CITY OF NOVI CITY COUNCIL
MAY 5, 2025

SUBJECT: Consideration of tentative approval of Feldman Kia, JZ24-32, with Zoning Map Amendment 18.746 to rezone property at the southwest corner of Grand River Avenue and Joseph Drive from Non-Center Commercial to General Business with a Planned Rezoning Overlay.

JZ24-32 FELDMAN KIA PRO

CAR HAULER TURNING
1" = 30'

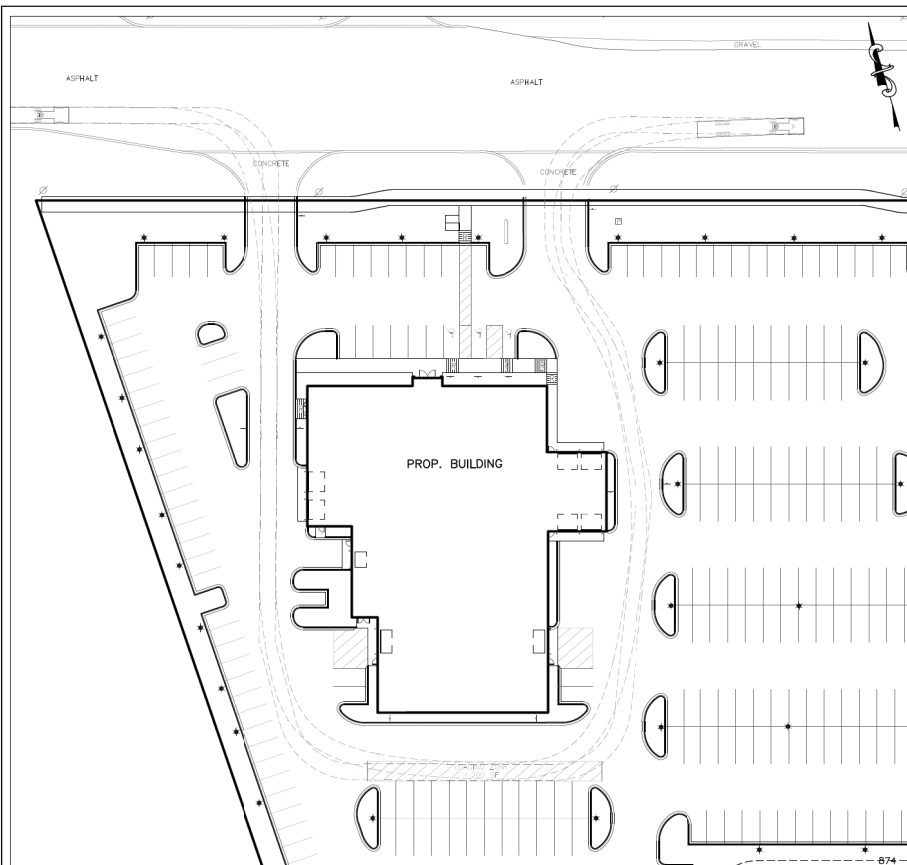
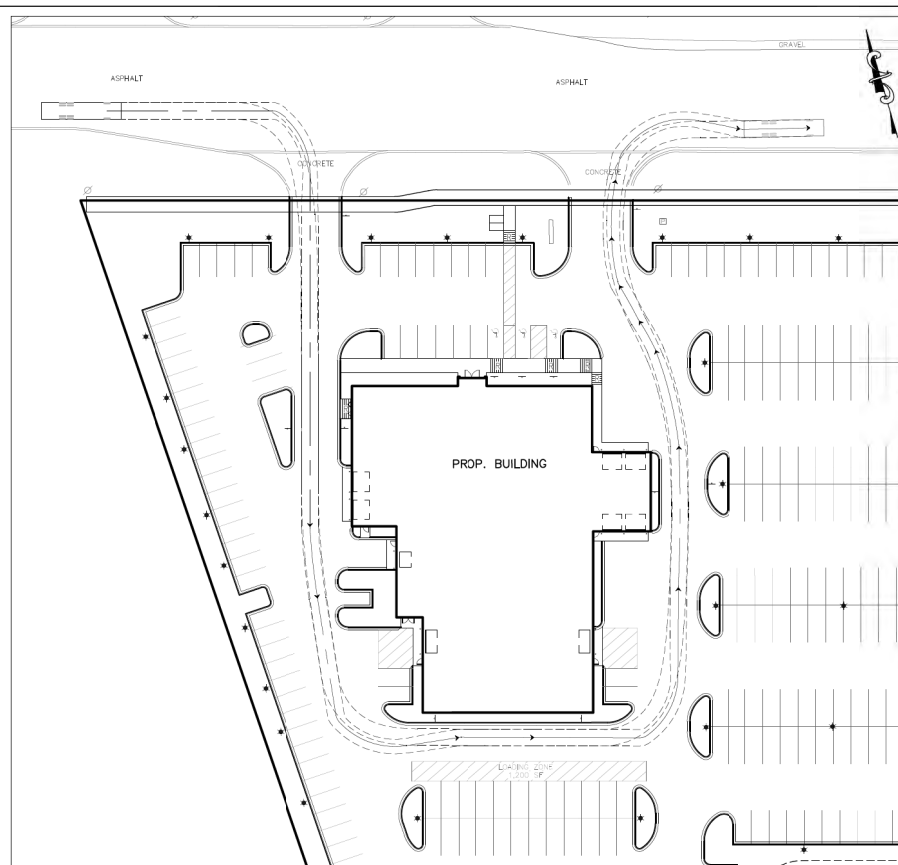
lot so that there is a clear path around the dealership to the rear parking lot with sufficient room for car hauler turning radius. See Site Plan sheet number 8 and below:

EXISTING CONDITIONS (PICTURE 1)
FACING SOUTHEAST

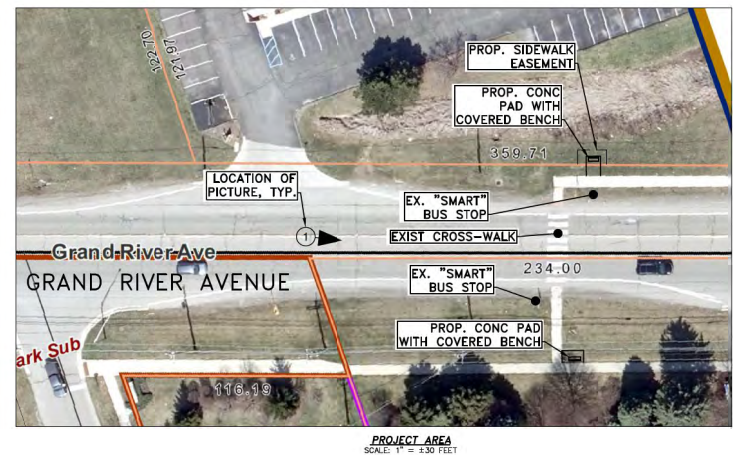
The applicant has also offered to **build covered shelters with seating at two nearby existing bus stops**. The images provided on Sheet 9 of the PRO Plan show **a paved pad with a shelter at the bus stops approximately 300 feet to the east of the property on Grand River Avenue, one on the north and one on the south**.

L-3

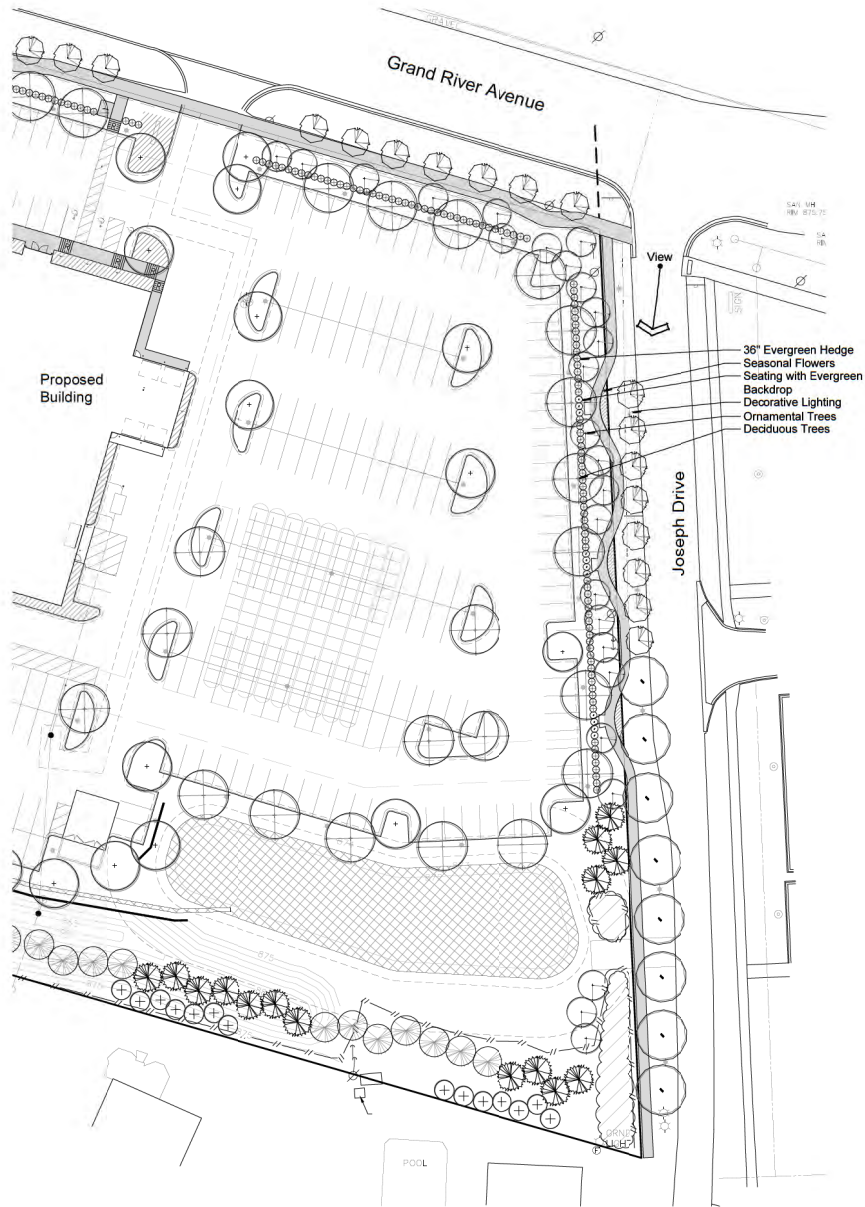
Staff Comment: Sheet L-4 of the PRO Plan shows a total of 3 benches to be provided at intervals along the sidewalk, and includes a detail of the proposed benches and decorative lighting fixtures. The benches and decorative lighting can be considered an enhancement. Providing a sidewalk on the Joseph Drive frontage is a requirement, so the meandering nature of it is the only unique feature, which may or not be considered an "enhancement."

ARCHITECTURAL SITE
PLAN - PRO SIGNAGE

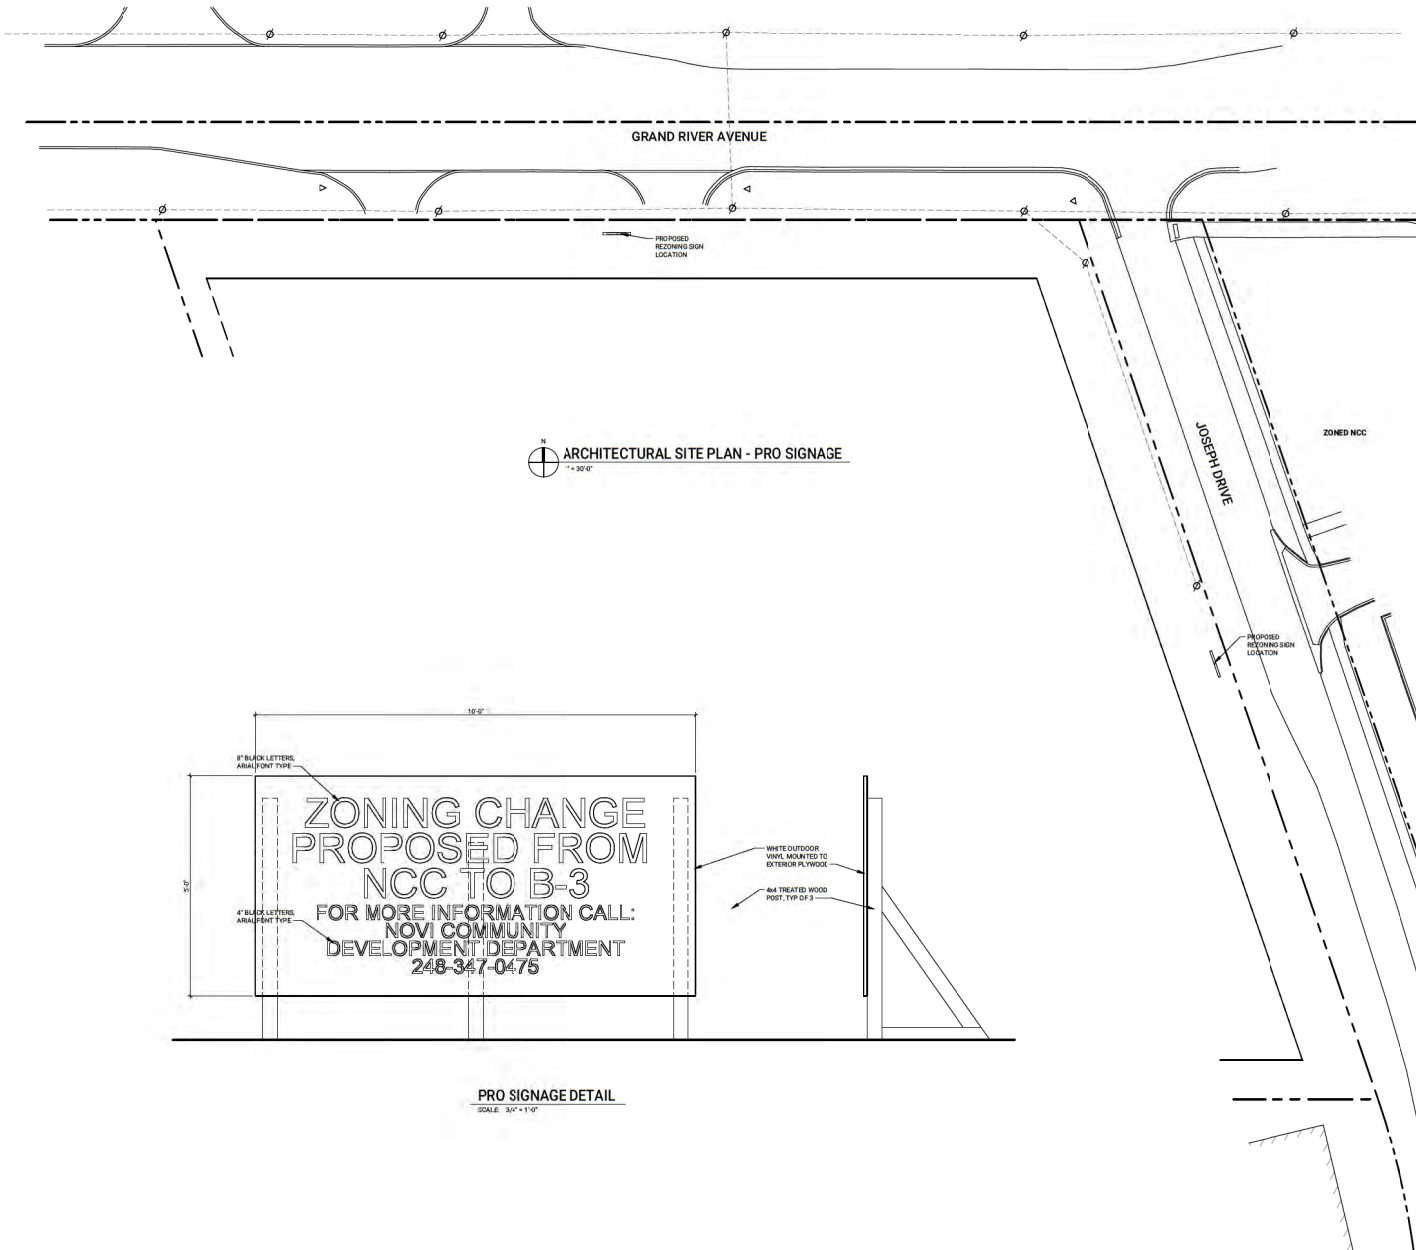
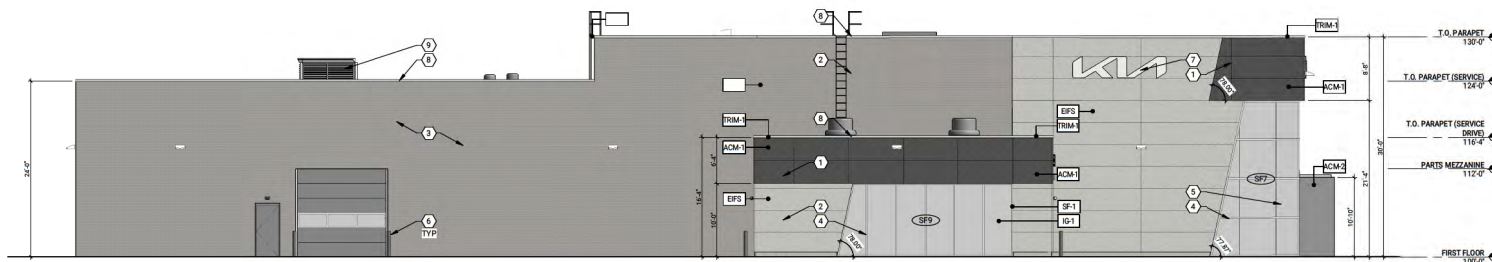
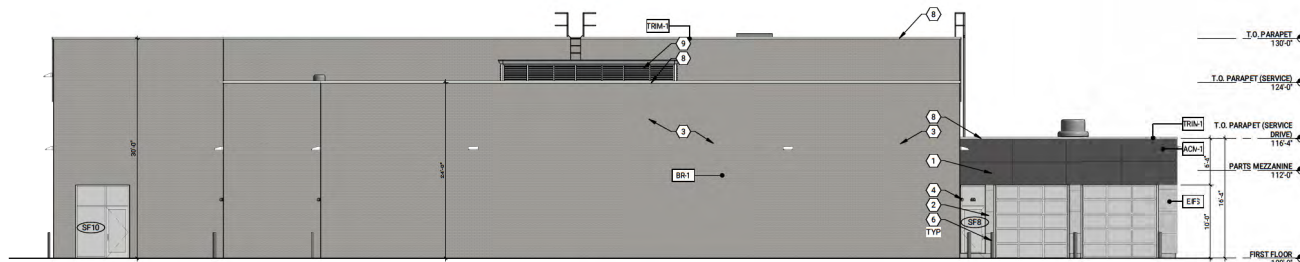
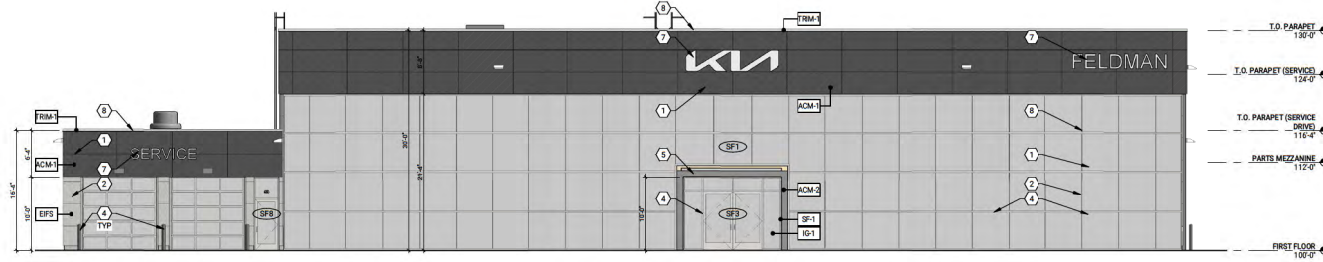
- d. Sign Location Plan: A rezoning sign location plan and sign detail has been provided on Sheet SP1.3. The sign locations and wording are acceptable, and were posted prior to the previous public hearing.
